**– 32 MANN STREET, GOSFORD – EARLY WORKS SSDA –
ARBORICULTURAL IMPACT ASSESSMENT**

At your request, I have reviewed the below documents and undertaken an impact assessment of the proposed works on the large *Ficus macrophylla* (Moreton Bay fig) in the southeast corner of the Central Coast Quarter development on Mann Street Gosford.

Figure 1

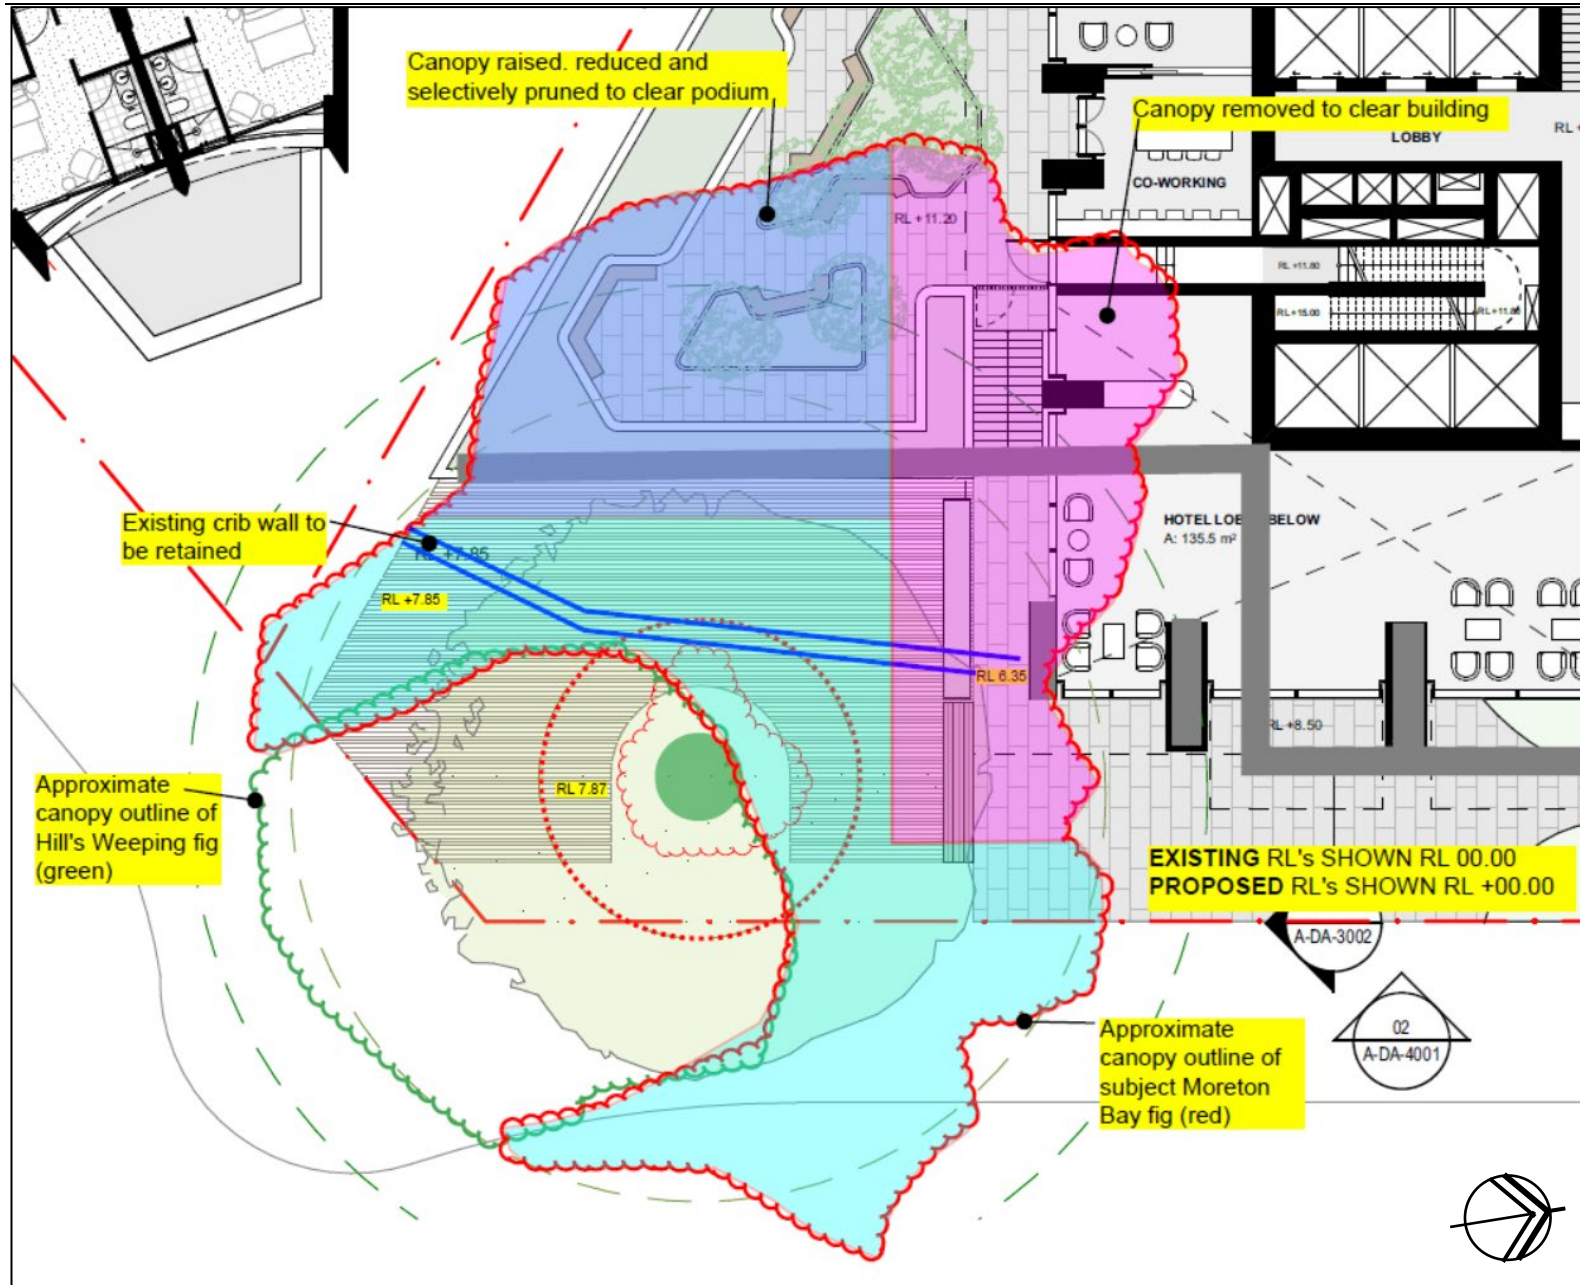
- Approximately 127m² (28.4%) for the eastern tower construction and clearance (including a 2m clearance from canopy to finished building offset).
- Approximately 112m² (25.0%) for clearance for basement piling (including a 1m clearance between piling rig and pruned tree canopy refer to Figures 1 and 2).

- Alternatives to the use of tall piling rigs to reduce the pruning of the western canopy spread of the MB fig are strongly recommended. Liaison with the project arborist during exploration of those alternatives is encouraged.
- Construction clearance of no greater than 2.0m from the south side of the eastern tower to accommodate scaffolding, and the like.
- Maximum pruning clearance of 4.0m above the southern podium (eastern tower).
- A detailed pruning specification as outlined above is prepared within 6 months so that pre-emptive pruning works commence prior to works related to the Eastern Tower begin.

Excerpt of A-DA-2006B Level 02 - Upper, marked up by C. Mackenzie. Not to scale.

Figure 2

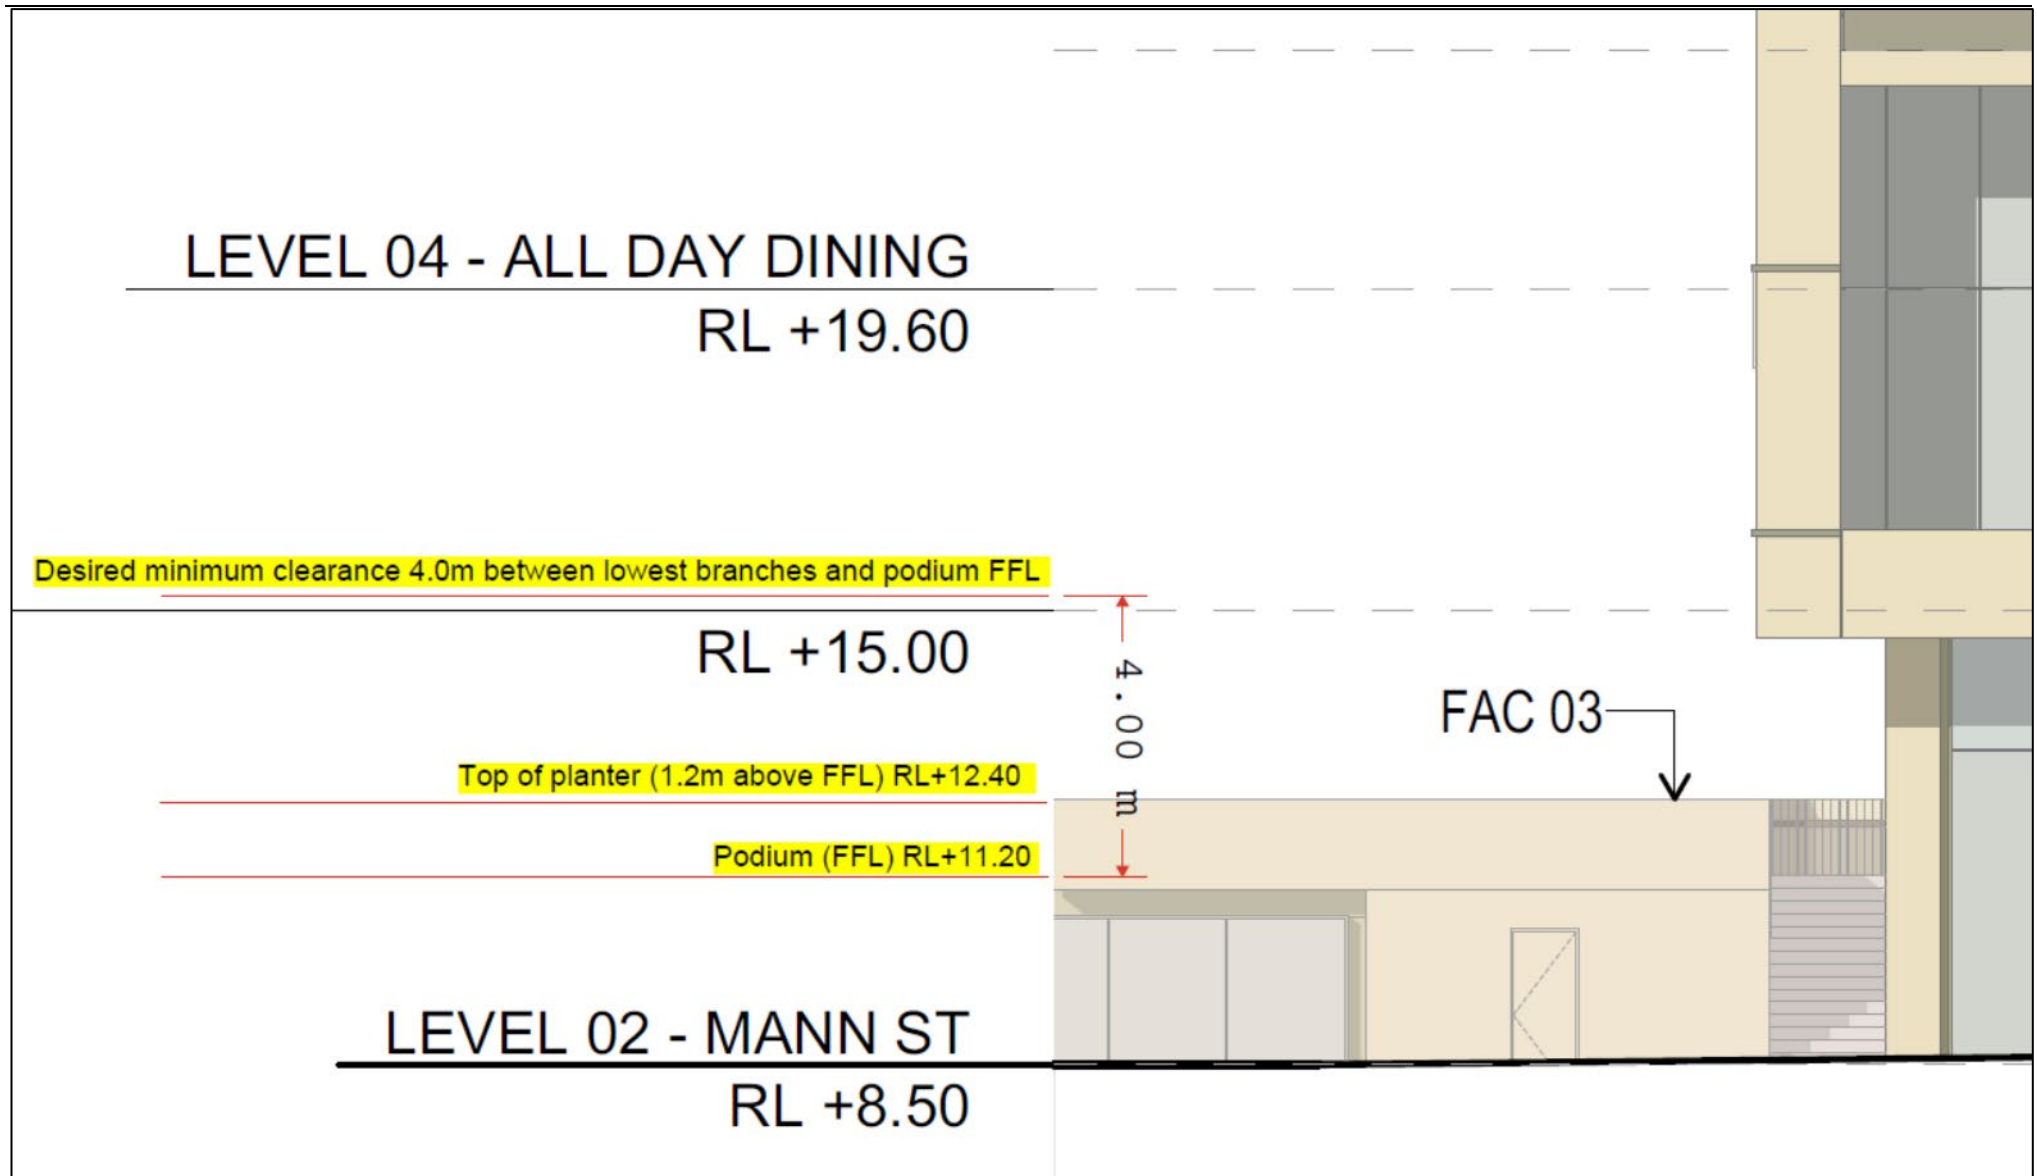
The above shows the approximate proposed podium and planter levels south of the eastern tower and recommended pruning clearance between the podium FFL and lowest branches of the subject fig tree. Excerpt of A-DA-4011 Eastern Tower East Elevation, marked up by C. Mackenzie. Not to scale.

Figure 3

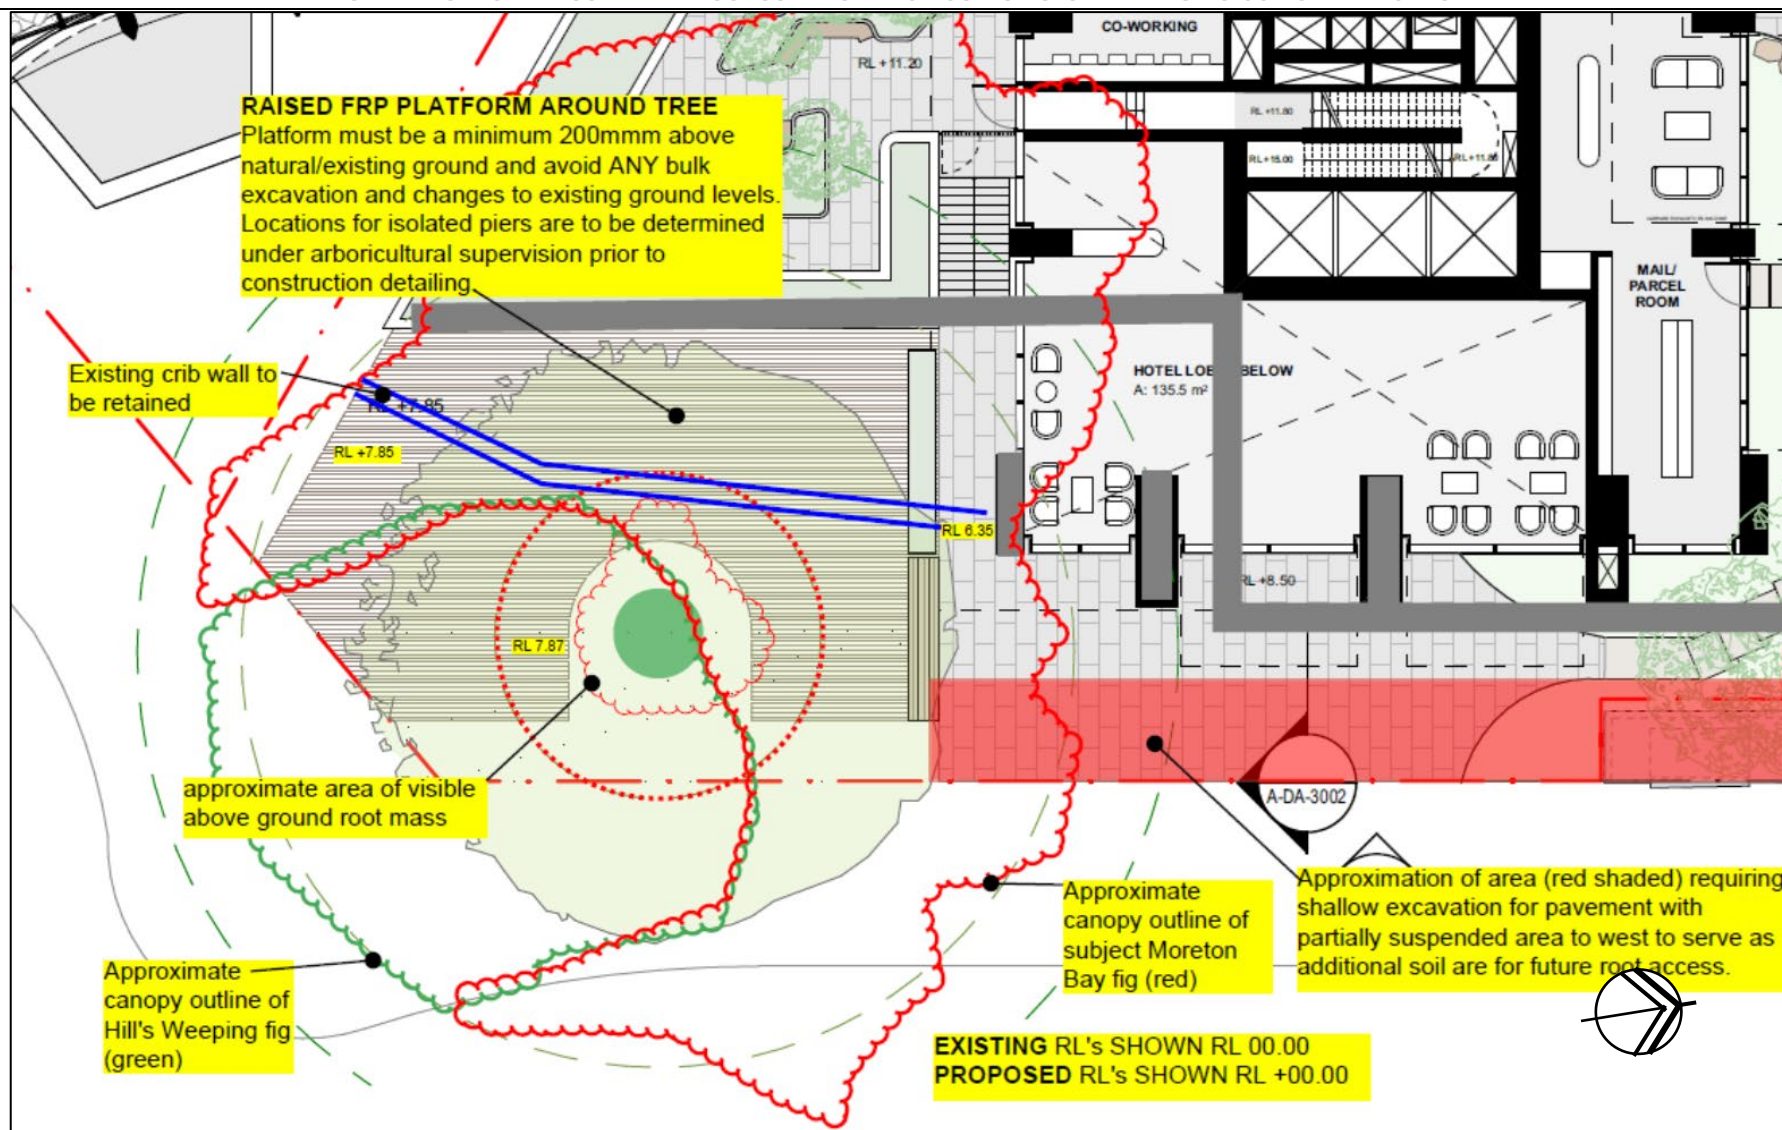
- The existing crib wall west of the MB fig is to be retained as illustrated on Figures 1 and 3.
- Future design of the raised FRP platform east of the existing crib wall is not to engage any changes (cut or fill) to the existing ground levels within the Tree Protection Zone of the MB fig. Isolated pier excavation will require arboricultural supervision.
- Proposed uplighting of the fig tree needs to be regulated to avoid prolonged interference with nocturnal fauna using the tree has habitat for roosting, feeding, etc.

Illustrating the approximate above ground, visible root mass of the subject tree within the notional Structural Root Zone (red dotted circle) and the built footprints of the tower and landscape hardworks. The added notes provide general instructions for future detailing for construction.
